**SPECIAL MEETING OF THE
CITY OF CONCORD
DESIGN REVIEW BOARD**

REPORT TO DESIGN REVIEW BOARD

Project Name: CALITHO WAREHOUSE (PL150147 – DR)
Review Status: Final Design Review
Location: 2371 Stanwell Drive
Parcel Number: APN's 112-251-006, -010
General Plan: Business Park
Zoning: OBP (Office Business Park)
Applicant: ATI
Attn: D. Rachel Hamilton
3860 Blackhawk Road
Danville CA 94506

RE: Design Review Re-submittal for
2351 - 2371 Stanwell Drive
Concord, CA 94520

SCALE: 1/8" = 1'-0"
 DATE: 6/30/2015
 DRAWING NO: 115
 SHEET NO: A3.1

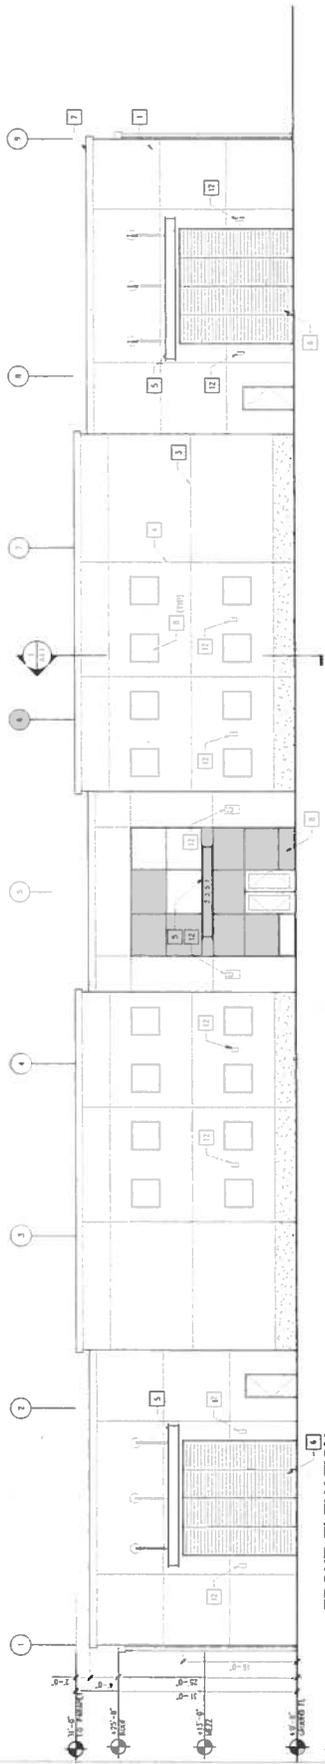
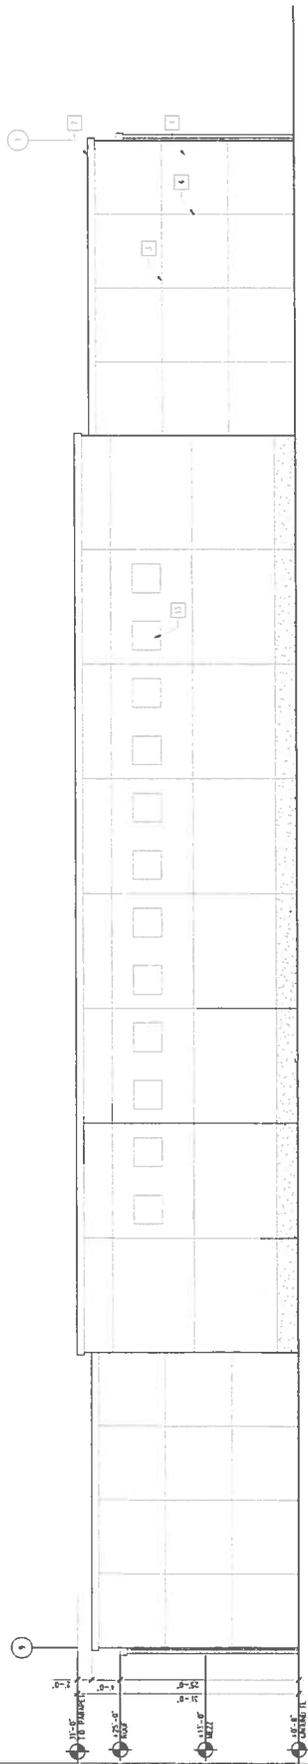
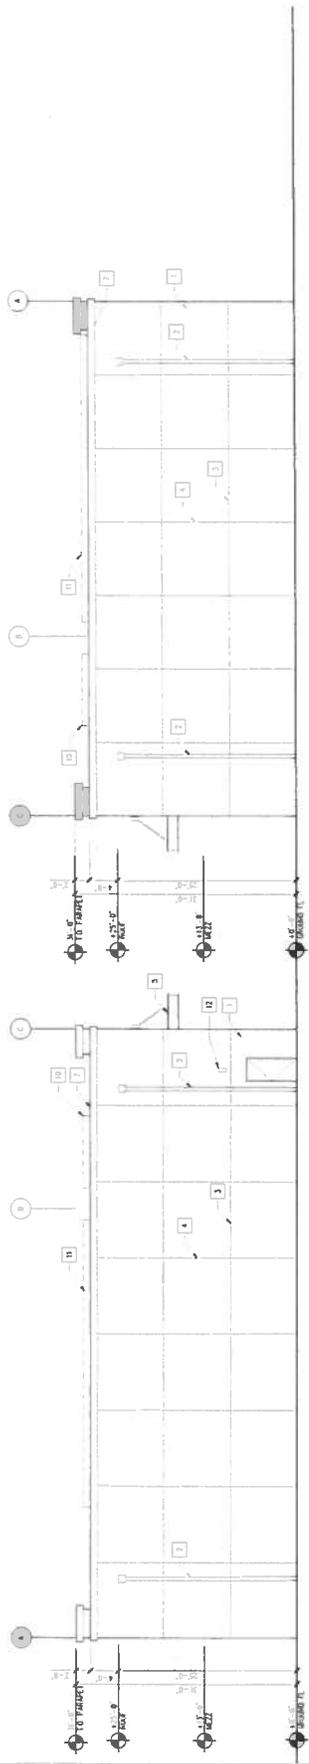
- *Provide adequate screening of the rooftop HVAC equipment and solar panels.*

- *Consider eliminating the pitched roof element. Consider the entry as a void set in from the tan "wing walls" and let the tan elements pop as the strong element.*

- *Cable ties should not be “tied” into the reglet.*

- *Architectural details should be consistent on all four elevations.*

We have modified the parapet system to better conceal rooftop equipment. Note that the solar panels are still shown installed on an angle. If the Board is concerned that these will be visible from below, we can modify them to be shown flat. Overall height of the building remains unchanged. See A3.1.

The elevations have been updated to reflect this recommendation. Note that the “blank” sections of the tan walls will serve as a backdrop for the Columnar Red Maples in the projecting planters. See A3.1, A3.1C and L1.

All concrete joints and scoring have been updated to avoid conflicts. See A3.1.

Please see A3.1 for updated elevations.

Exterior Study - View of Proposed Southwest Corner

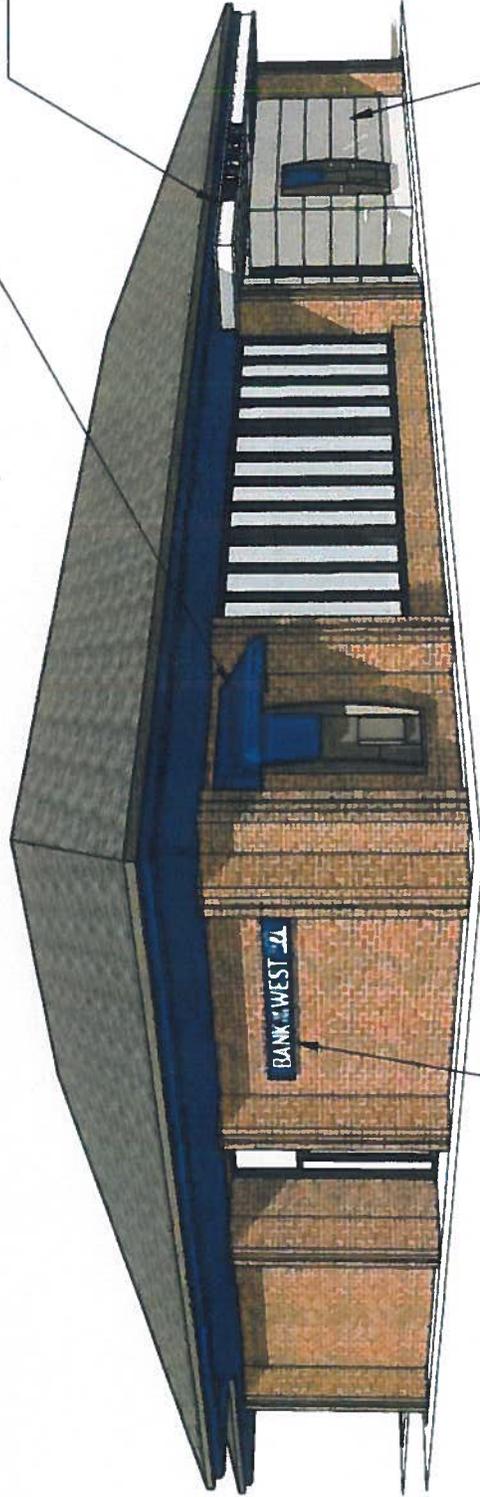
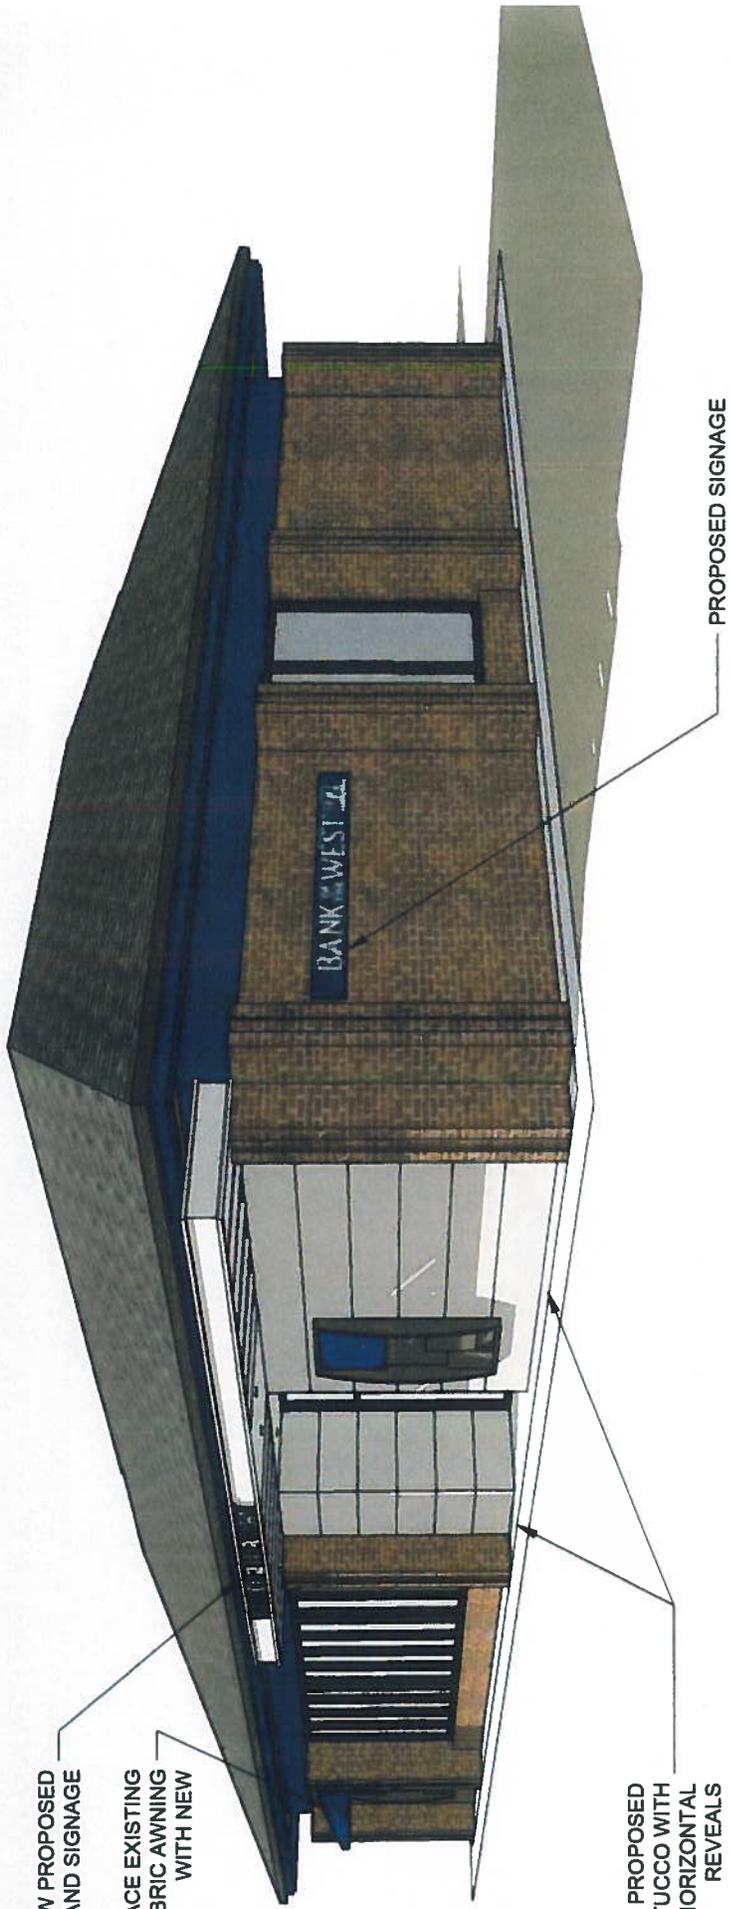
- Evaluate how the new canopy relates to the existing roof. The plan juxtaposes two different design elements that have the same function except that the canopy includes new signage. Staff recommends integrating the sign into one roof or canopy element that creates a seamless and uniform look.
- Consider popping-out the entrance and/or opening it up with new storefront as a way to further enhance the entry area.
- Return with design details for new signage. New signage shown on the elevation facing Diamond Boulevard should be omitted from the plans because it will be screened by an existing tree.
